ADDENDUM

ADDENDUM NO.: 01

PROJECT NAME: Williams Park Fieldhouse

DATE OF ISSUE: January 12, 2018

PARTIAL SITE PLAN

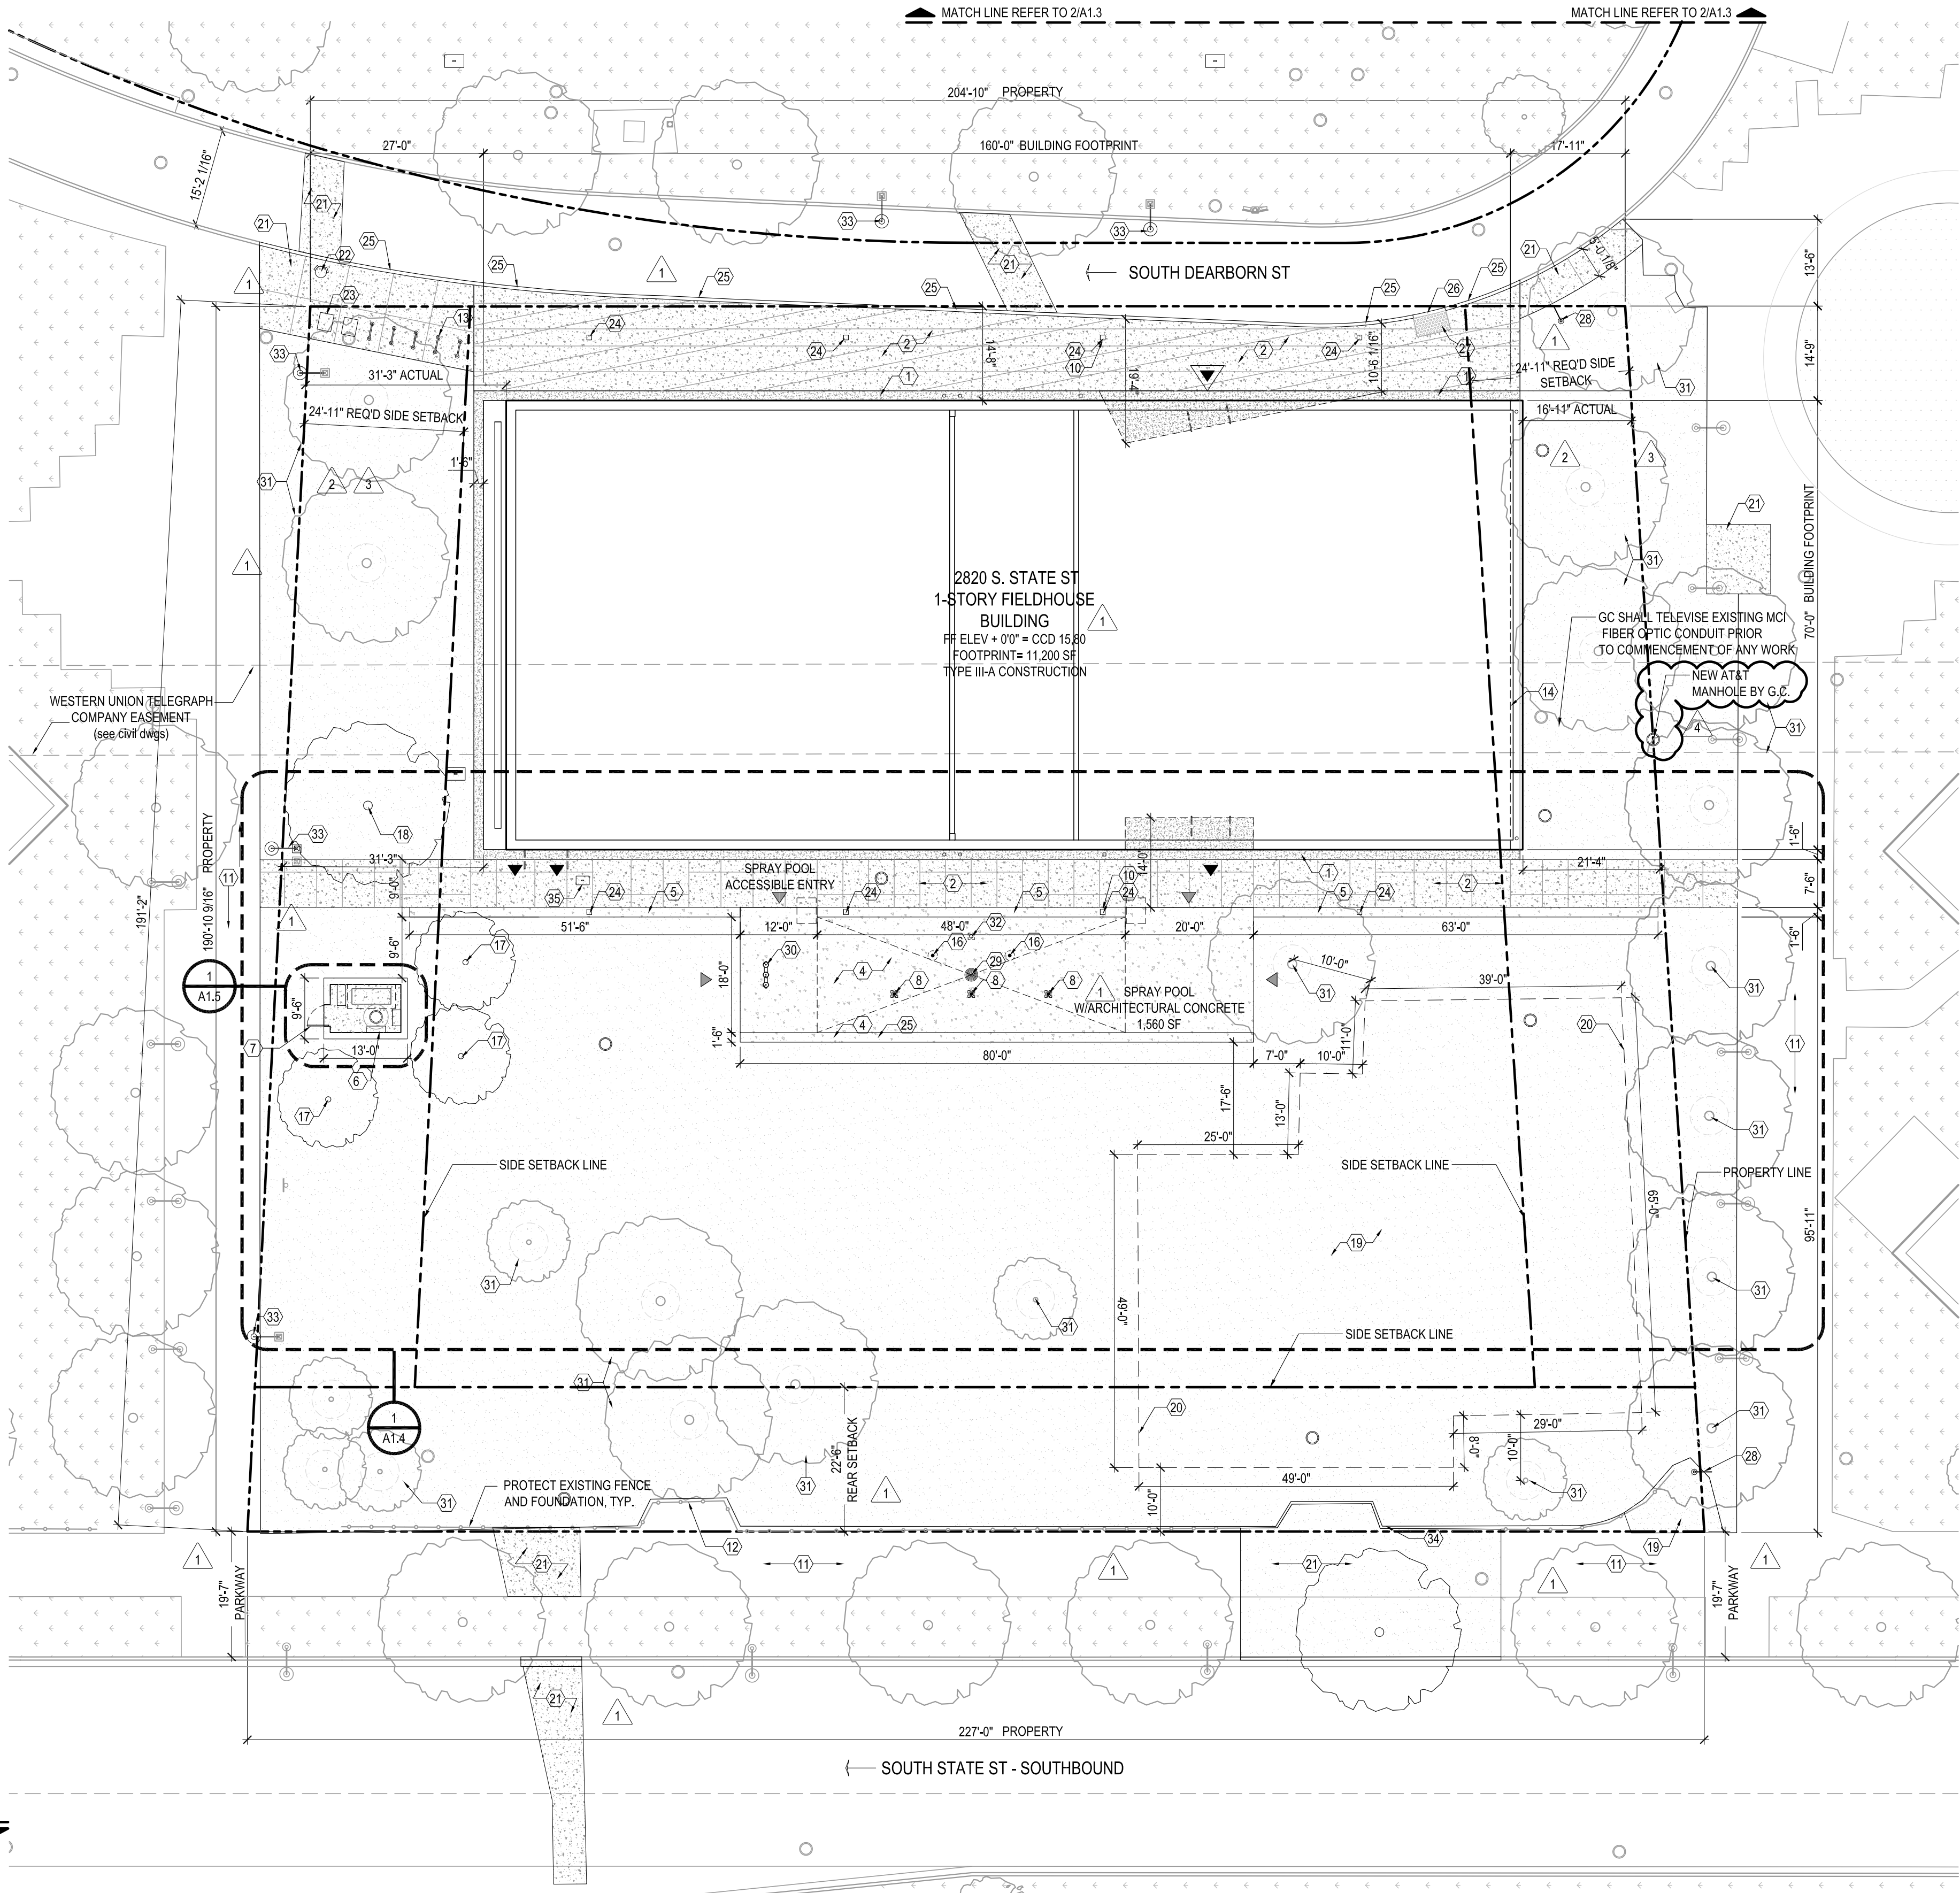
Change 1. **REVISED** Drawing C1.0, C1.4, A1.3, T2.1, to add a new AT&T manhole.
